Preliminary Consultation
MONTGOMERY COUNTY HISTORIC PRESERVATION COMMISSION
STAFF REPORT

Address:	24227 Hawkins Landing Drive, Gaithersburg	Meeting Date:	8/14/2024
Resource:	Master Plan Site #14/14 Bowen-Woodfield Farm	Report Date:	8/7/2024
Applicant:	William Kirwan, Muse Kirwan Architects	Public Notice:	7/31/2024
Review:	Preliminary Consultation	Staff:	Laura DiPasquale
Proposal:	Porch and fenestration alterations, basement alterations

Figure 4: East elevation drawings, existing (left) and proposed (right). The red arrow points to the location of the proposed window.

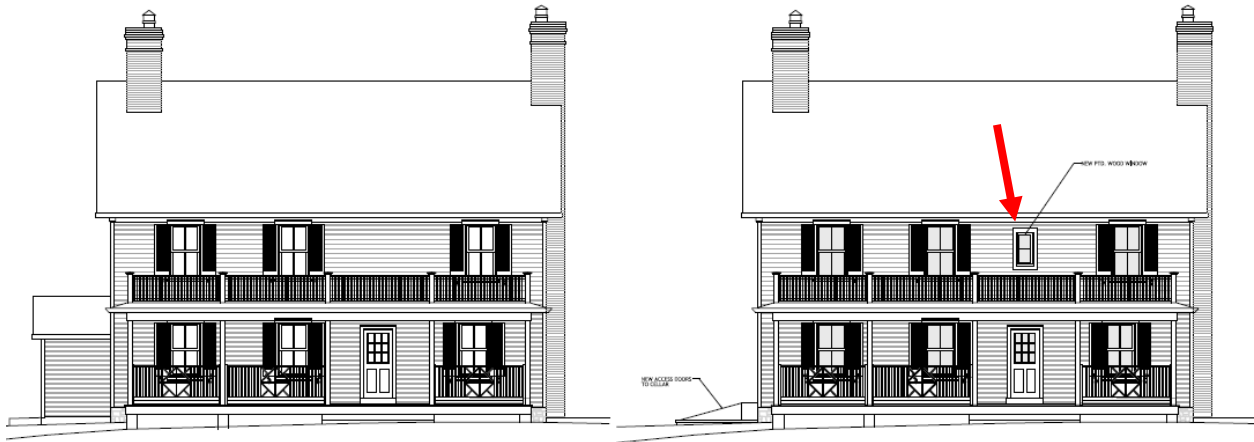
The applicant proposes a minor alteration to the façade of the original house (Figure 3). On the second story, a small, one-over-one, double-hung, wood-sash window would be installed directly above the main entry door. Staff finds that the new fenestration would have minimal impact to the overall design. In addition, the proposed wood-sash window compliments the existing materials, but its smaller dimensions, one-over-one design, and lack of shutters clearly differentiates it from the original windows. Therefore, the proposed alteration satisfies *Standards* #2 and #9.

Figure 8: South elevation drawings, existing (left) and proposed (right).

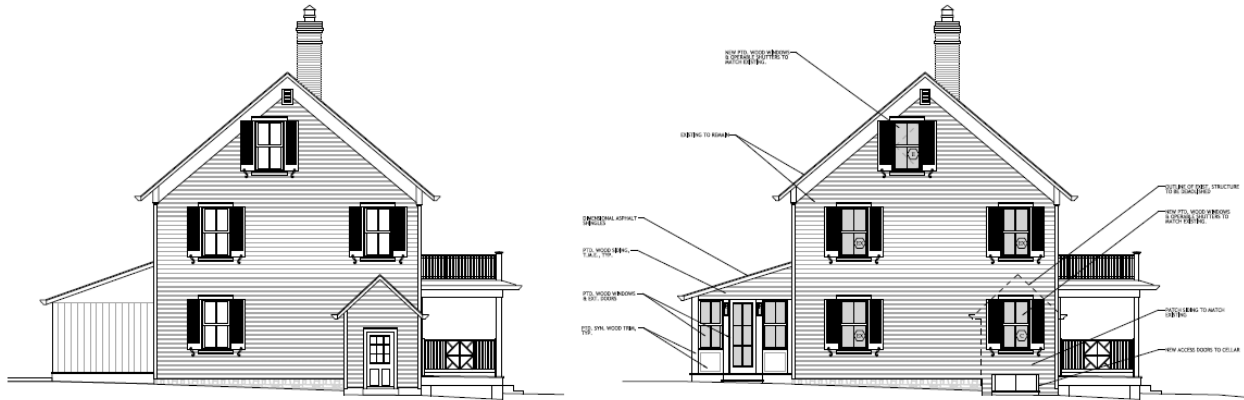
The applicant proposes to remove the existing gable vestibule covering the cellar entrance and replace it with a Bilco (steel) door. Staff has not determined the precise age of this vestibule but notes that the detailing is similar to that of the main house with matching Dutch lap siding, slate roofing, overhanging eaves, and other details that suggests it was added in the early 20th century but likely not an original feature of the dwelling. Staff finds that the gable addition is not a character defining feature of the historic resource and supports its demolition. The proposal calls for a new two-over-two, double-hung, wood-sash window that matches the design, material, and dimensions of the other windows on this elevation in the location of the demolished vestibule. Staff finds that the alteration would not adversely affect the character defining features of the dwelling and satisfies *Standard #2*.

Figure 9: South elevation drawings, existing (left) and proposed (right). The red circle show the location of the window proposed to be replaced.

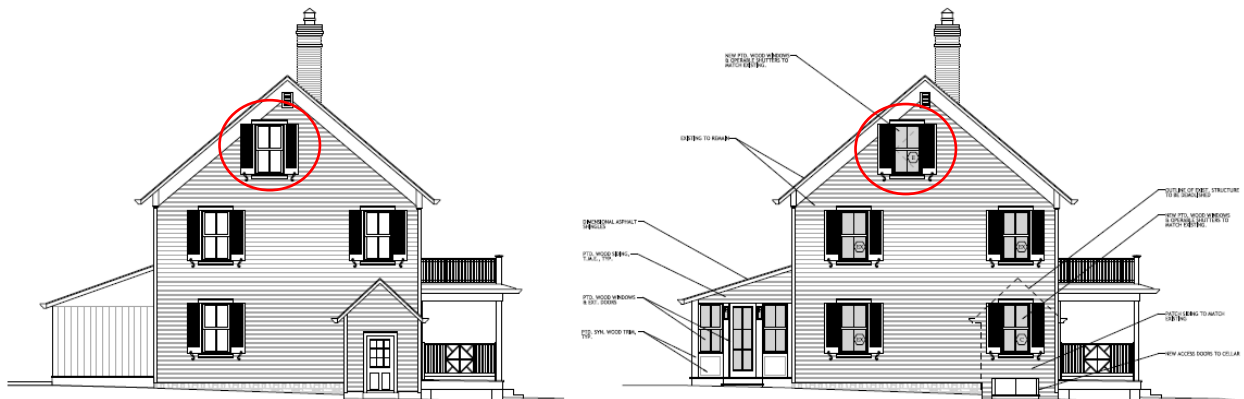
The applicant proposes to replace an existing double-hung window with a casement window of matching dimensions (Figure 9). For the HAWP, the applicant must submit a narrative that justifies the replacement of this window in lieu of its repair to satisfy *Standard #6*. Materials should include photographic documentation of the deteriorated condition (if relevant). In addition, full specifications that illustrate that the proposed casement window mimics the appearance of the existing double-hung window would be required.

Figure 13: Site plan showing the proposed bluestone walkways and terrace south of the house.

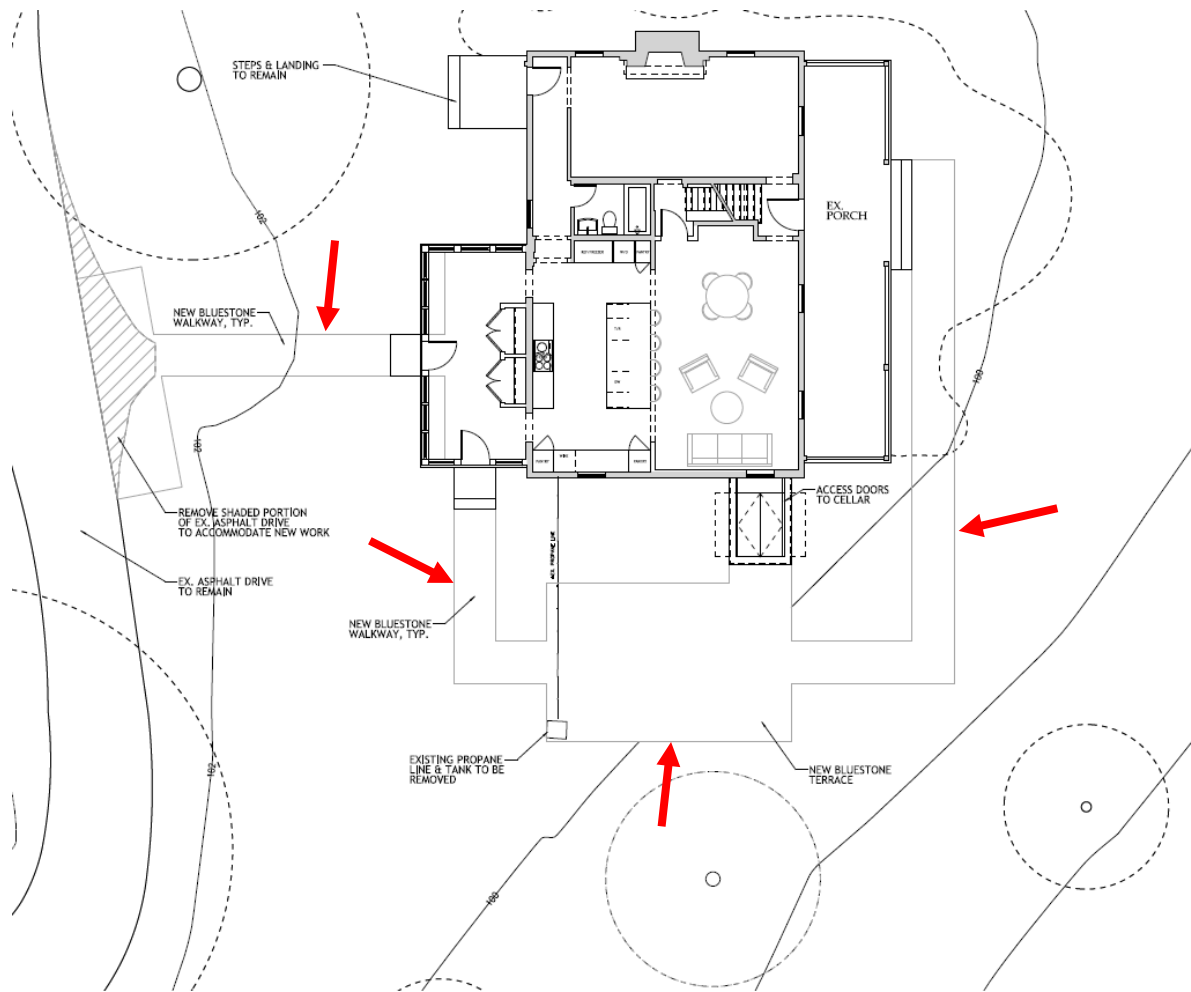
The applicant proposes to install a new terrace adjacent to the south elevation of the house with walkways accessing the east and west elevations and extending from the addition west to the driveway. A note on the cover sheet indicates that “additional grading will be necessary to accommodate new terraces etc...” Staff notes that the modified grading is not shown in the preliminary submission and that the terrace and some walkways are not shown in elevation or section. Provided the grading and excavation are minimal and a tree survey demonstrates that the proposal will not adversely impact any significant trees, staff finds that a bluestone paving material is compatible with the historic property and that proposed walkways and terrace will not have an adverse effect on the historic property, and will satisfy *Standards #2 and #9*. Staff notes that additional grading information and a tree survey should be submitted as part of the HAWP.
